ALERT SERVICE BULLETIN

206L-16-179

MODEL AFFECTED: 206L-1, 206 L-3, and 206 L-4

SUBJECT: ENGINE, COMBUSTION ASSEMBLY - INSPECTION OF OUTER COMBUSTION CASE P/N M250-10404

Examples of Acceptable Weld Sizes
FIG. 1

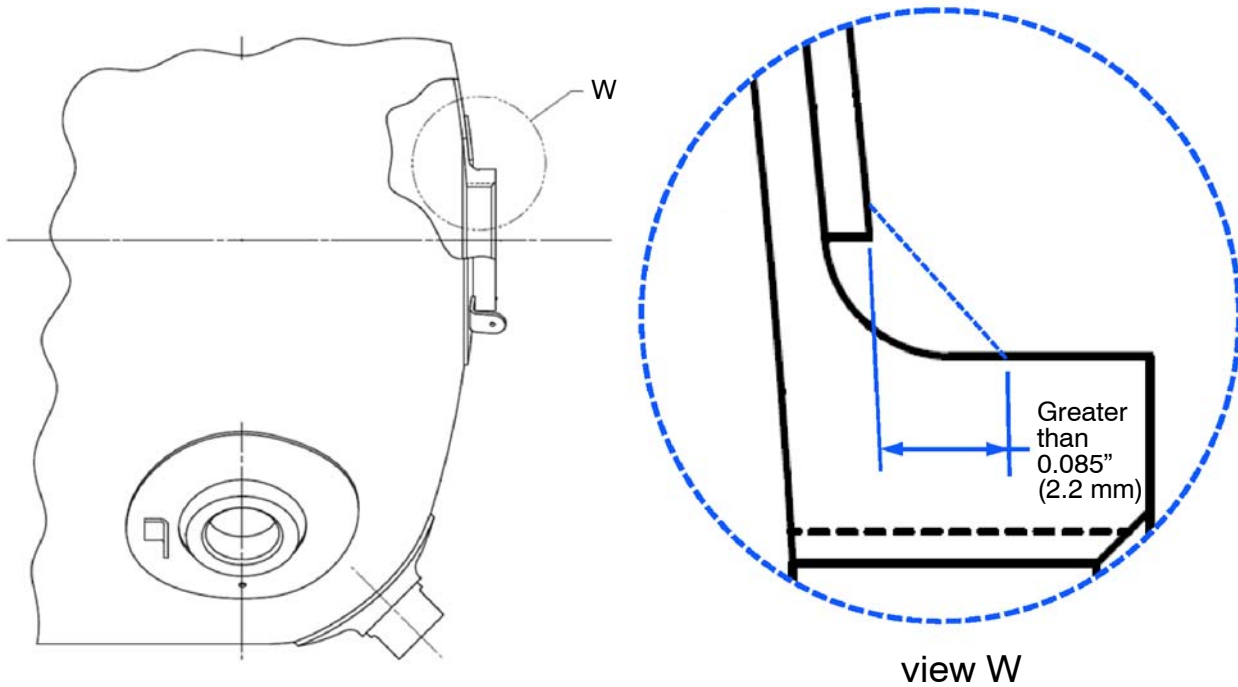
- (1) The inner fuel nozzle boss weld depicted in [Fig. 1](#) must be at least 0.085 in. (2.2 mm) in height as measured from the fuel nozzle boss doubler.

- (3) If the fuel nozzle boss inner weld does not meet the size requirements in
- [Fig 1:](#)

NOTE: OCCs that do not meet the definition in Fig.1 are required to continue the recurring 25 hour inspection requirement.

- (2) If the leg of the weld meets the minimum size requirements at all circumferential locations around the fuel nozzle boss:
 - (a) Mark the letters CW adjacent to the part number in accordance with AS478-2D1 shallow vibro-peen to track bulletin compliance.

Examples of Weld Sizes for Recurring Inspection
FIG. 2

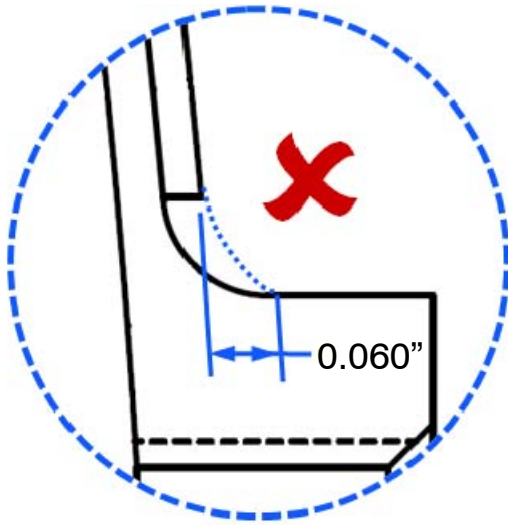
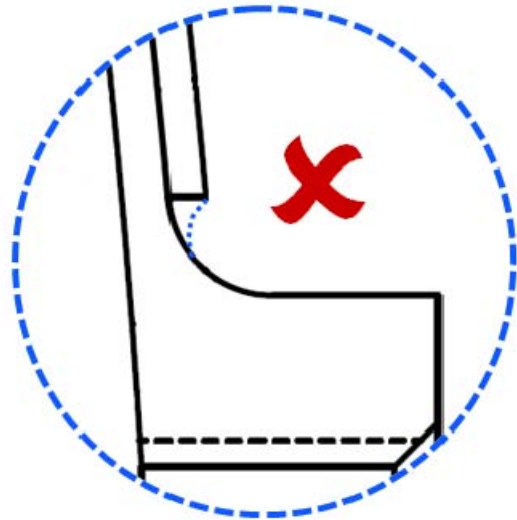
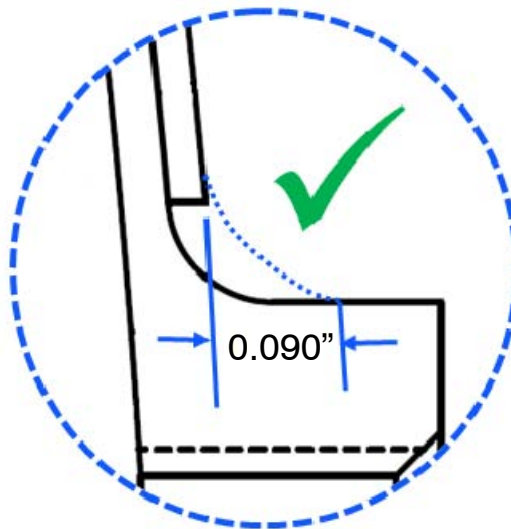
NOTE: Additional clarification on the acceptance criteria is shown in [Fig. 2](#). The figure contains examples of weld sizes and can be used as a guide to interpret the measurement requirements. The figure does not provide accept or reject criteria.

Visual Inspection Areas of the Combustion Case
FIG. 3

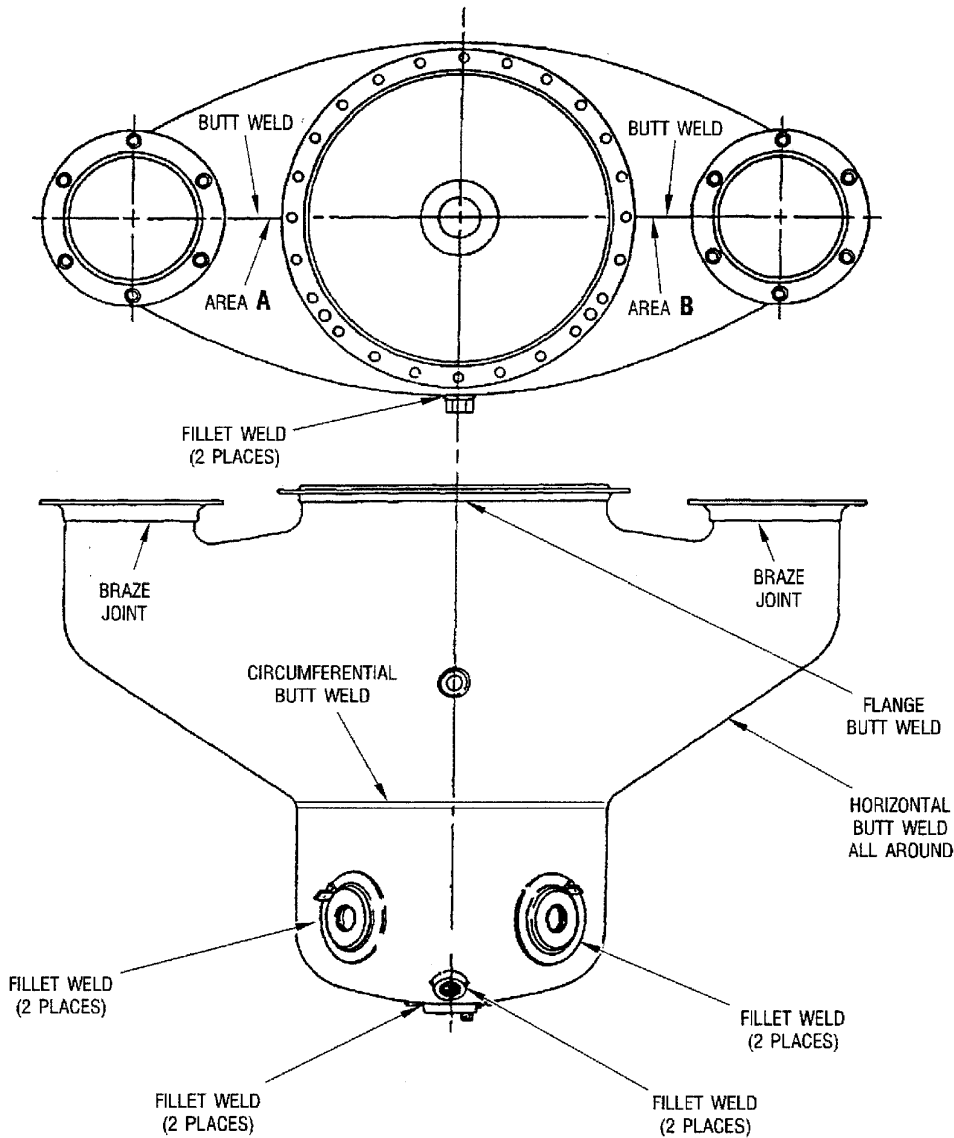
- (1) With a bright light (flashlight or equivalent) and mirror, inspect all the welds on the OCC (see
- [Fig. 3](#)
-). No cracks are allowed. An outer combustion case that is cracked must be removed from service and repaired. Welded areas are:

- (a) Horizontal butt welds on outer surface and between the air discharge tube attachment flanges and gas producer attachment flange on forward side.
- (b) Both forward and aft circumferential seam welds between outer case and inner liner.
- (c) Welds for attaching bosses for fuel nozzle, both combustion case drain valves, both igniter plugs.

NOTE: Pay particular attention to the welds in areas that surround the threaded fuel nozzle boss.
